**Regarding: 11V-483**

## SAFETY RECALL

## ALL 2009 ~ 2011 VMX17YB, YCB, ZR, ZCR, AG, ACG MODELS FACTORY MODIFICATION CAMPAIGN – Oil Pump Failure

### Part Identification

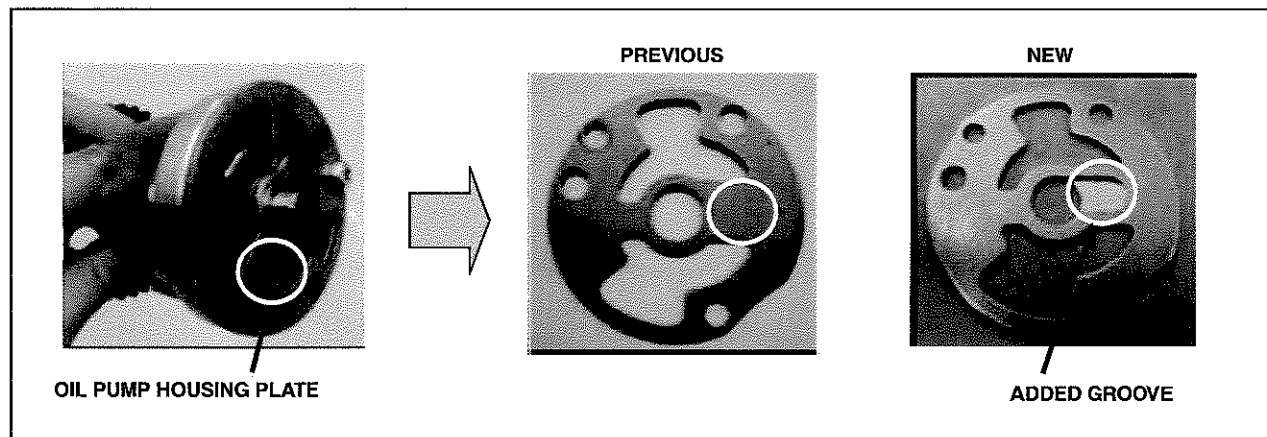
A groove has been added to the new oil pump housing plate. Please check the groove for part identification (see photos below).

**NOTE:** Replacement parts in inventory are all of the corrected type.
